SERVICE BULLETIN

MODEL BD-700-1A10 (BD-700)

**MODIFICATION – HORIZONTAL STABILIZER –
 ADDITION OF DRAINAGE HOLES TO ELIMINATE WATER ACCUMULATION AND
 ADDITION OF RIVETS ON THE ACCESS PANELS NUTPLATE ASSEMBLIES**

SERVICE BULLETIN: 700-55-004 **ISSUE:** Basic **DATED:** Jul 26/2002

KGC991-1098
Kit - Gang Channel Instl, Shroud Panels, H/Stab
(Sheet 2 of 2, Rev. C)

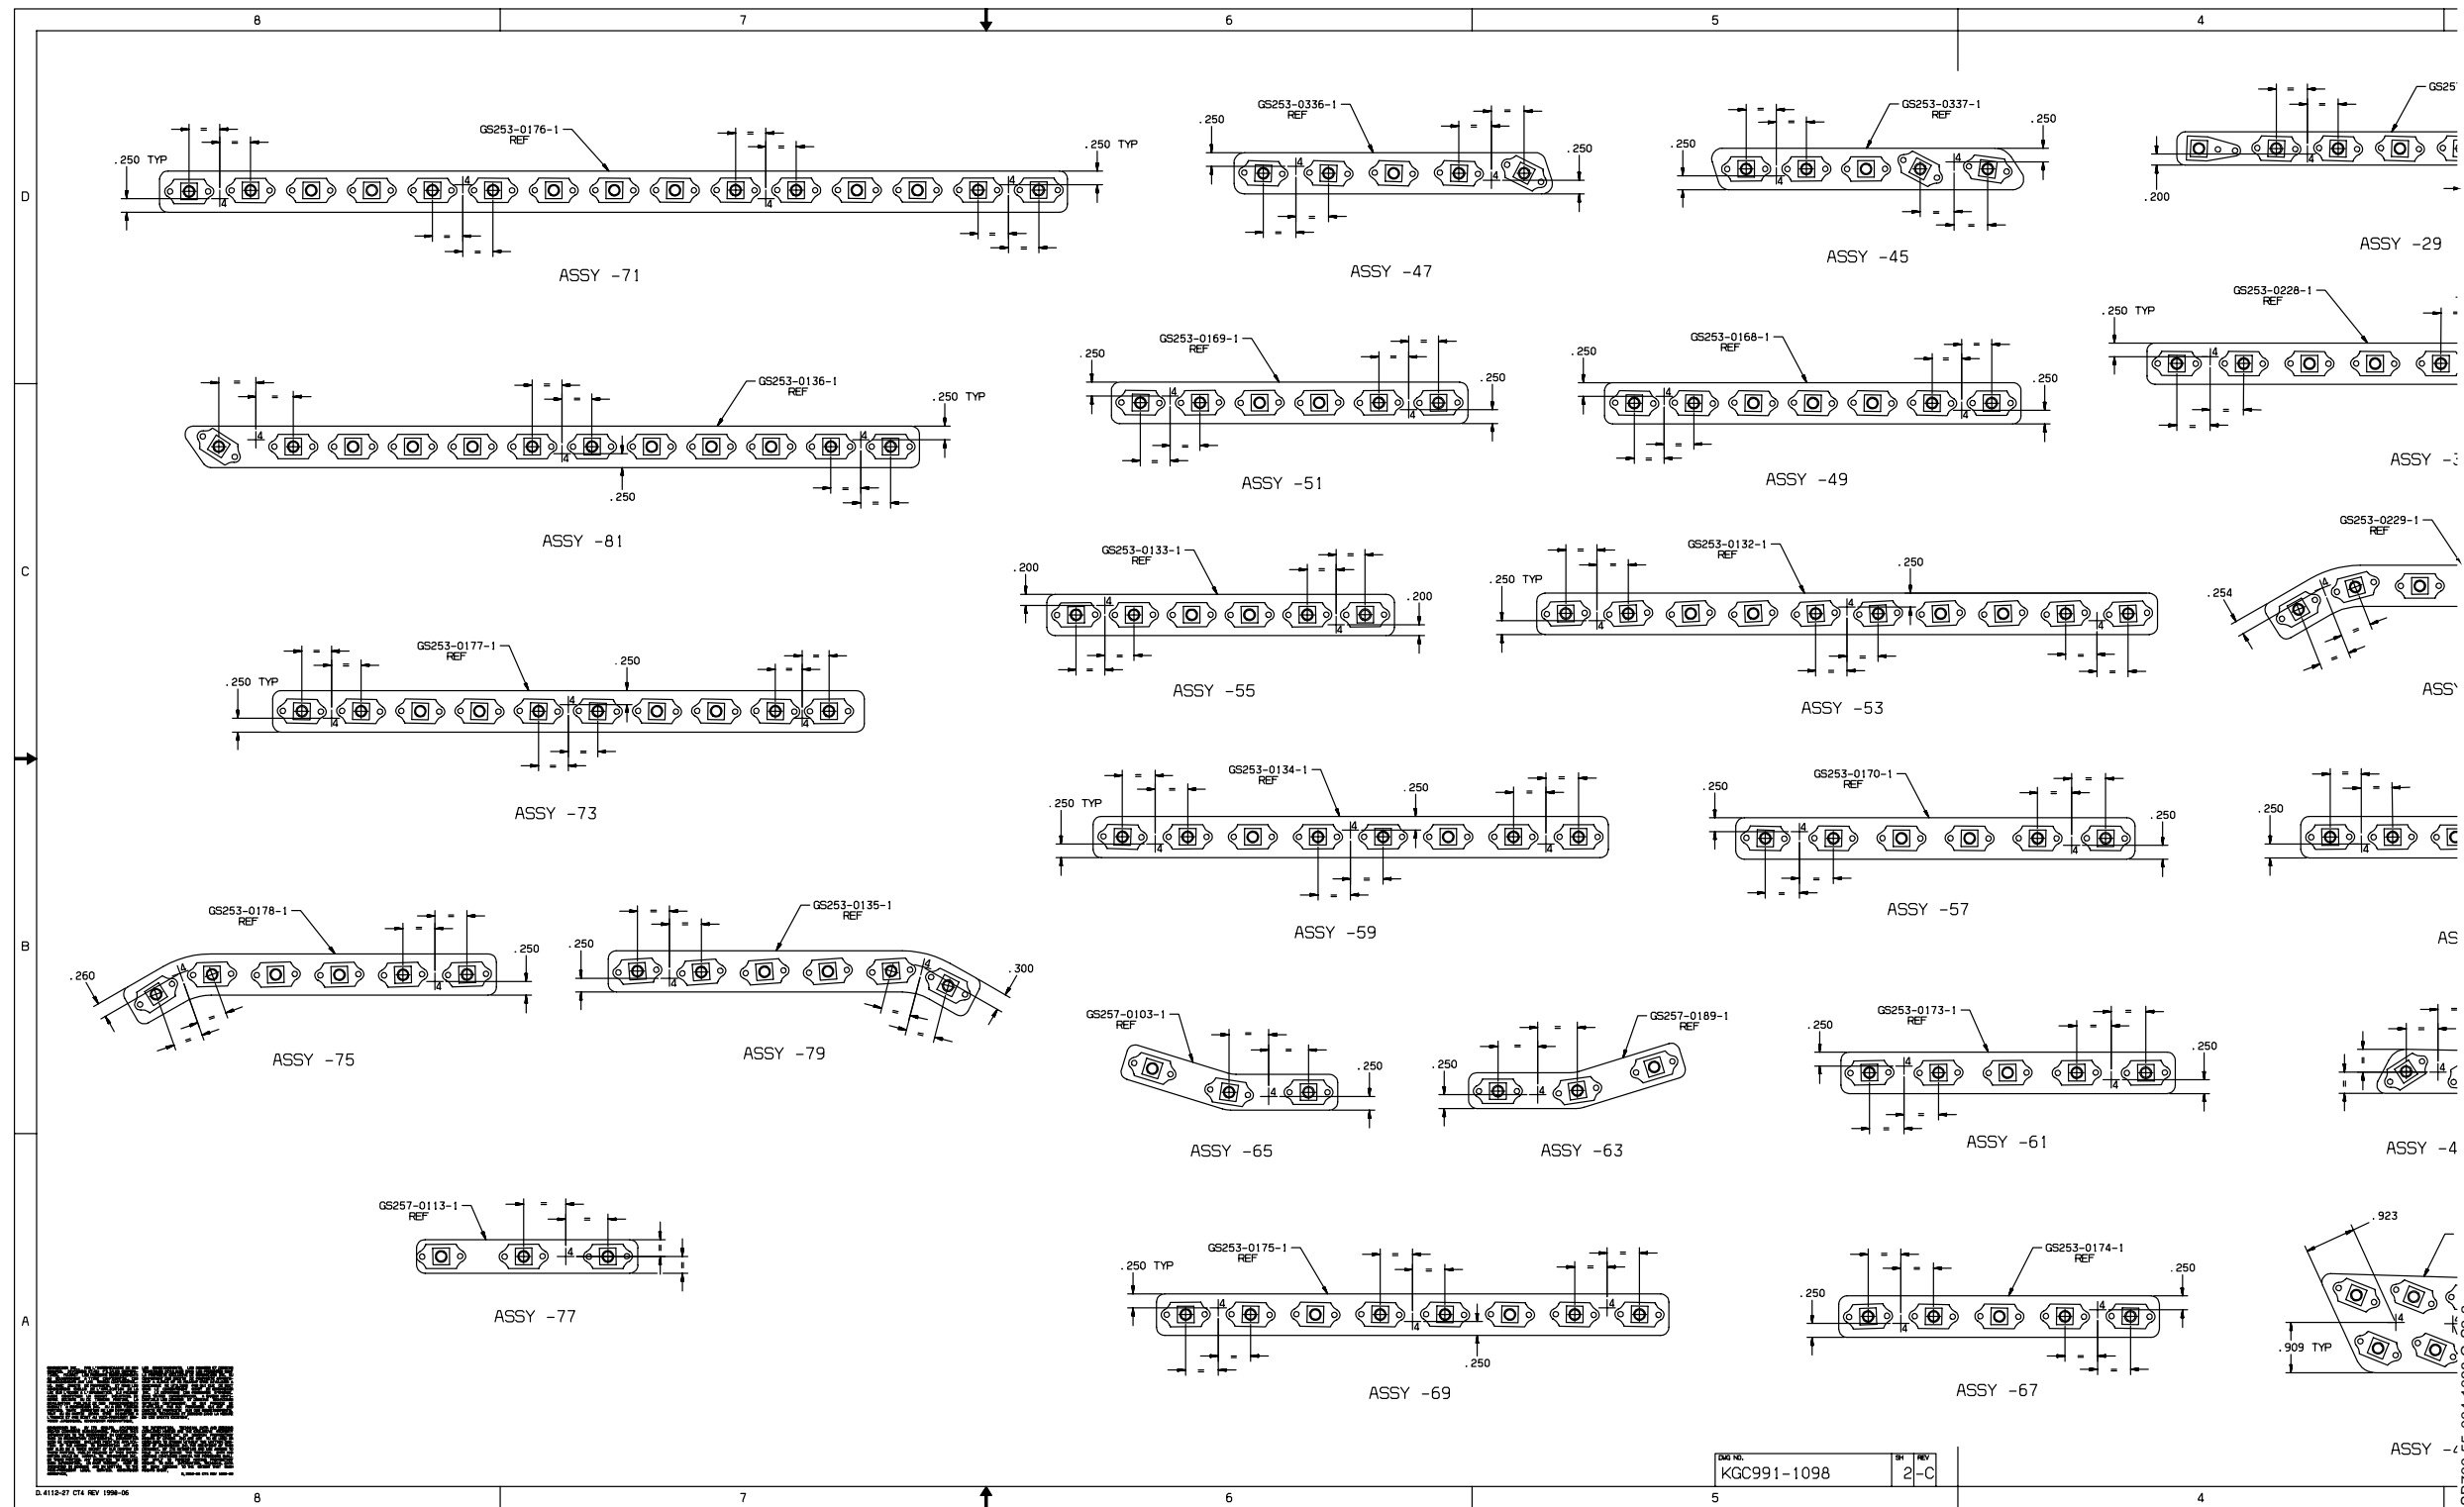
Nutplate assemblies are bonded to the horizontal stabilizer structure. During screw installation, the shroud panels of the nutplate assemblies (gang channels) easily come unbonded from the horizontal stabilizer structure. PART B of this Service Bulletin gives instructions to add an inter pitching of rivets to give more rigidity and prevent the gang channels from coming off.

- Get access to the horizontal stabilizer, and
- Do the modification of the gang channels as per Kit Drawing KGC991-1098.

- (3) Do the modification to the nutplate assemblies as given in the Kit Drawing KGC991-1098.

NOTE: Cold bond nutplates strip KGC991-1098-25 using epoxy EA9345 A/B or EA9309.3 A/B. Refer to TASK 51-21-53-340-801.
